**RE: Upper Burdekin Wind Farm – Request to vary proposal to take an action [EPBC2021/9066]**

Upper Burdekin Wind Farm Holdings Pty Ltd also wishes to seek approval for a smaller wind farm footprint than that which has been proposed in the 2022 variation. The varied proposed action will include construction, operation and decommissioning of up to **69 wind turbine generators** and ancillary infrastructure. Please see Figure 1 below for a visual representation of the 69-turbine layout.

Figure 1. A – Varied layout (69 wind turbines and associated infrastructure).

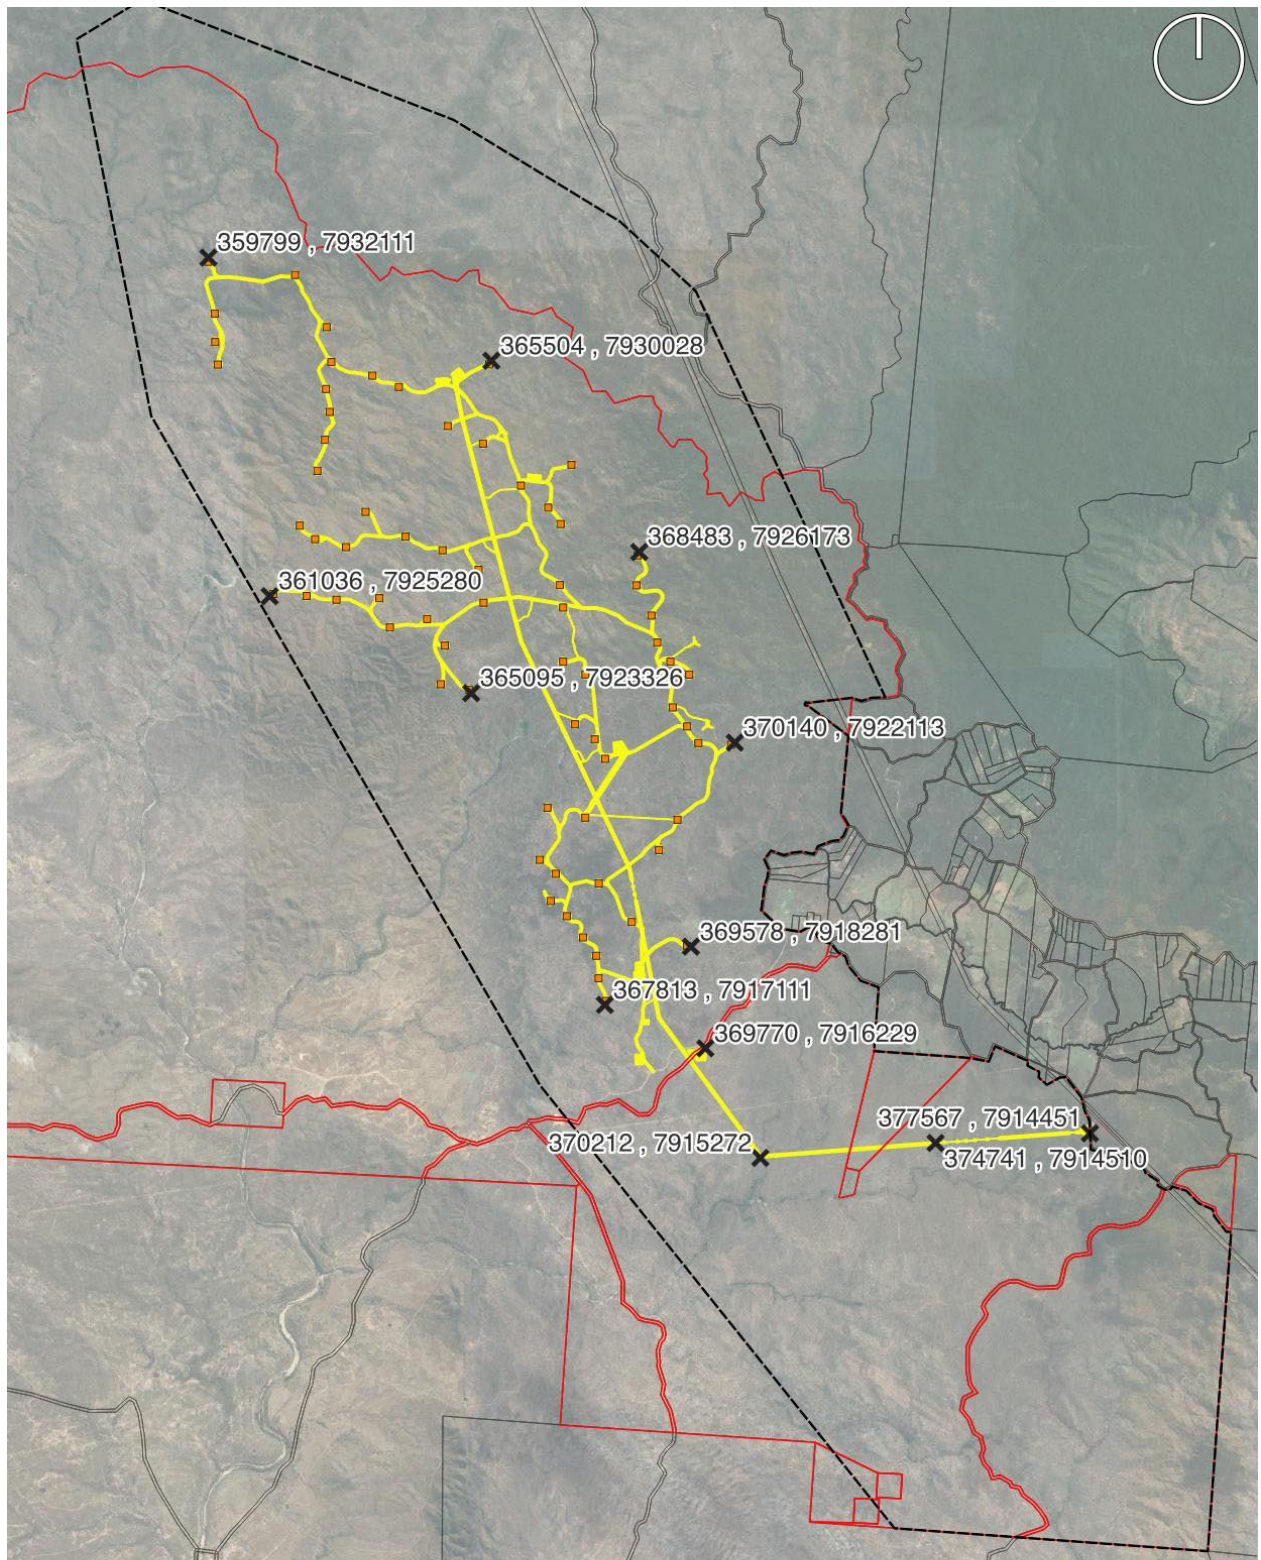
In order to optimize the new turbine layout there have also been associated updates to the location of infrastructure, including a relocation of the concrete batching plant, a reduction in clearance corridors and a realignment of the transmission line, which runs more directly through the reduced spine of the wind farm and then south-east, to tie into the Powerlink Guybal Munjan Switching Station. The design of the transmission line also includes the following measures to further reduce impacts to MNES:

- Selectively placing transmission line towers in already cleared areas or in areas of lower ecological value;
- Using taller towers so that the existing canopy can be retained where possible; and
- Clearing the minimum required for safe operations.

The varied and smaller footprint is intended to prioritise environmental preservation, while at the same time producing the best wind resources for a balanced, efficient and high performing asset. The new layout reduces impacts to MNES via:

- Reduced direct impacts, including:
  - Reductions in the extent of habitat removal for threatened and migratory species; (refer Table 1 below);
  - Reduction in habitat fragmentation via reduced clearing corridors throughout the project footprint; and
  - Reduced risk of turbine collision and barotrauma for aerial species due to fewer wind turbines.
- Avoidance of key discrete habitats for threatened species via relocation of concrete batching plant outside of areas considered to be breeding habitat for Sharman’s Rock Wallaby and removal of turbines in potential Magnificent Brood Frog habitat.
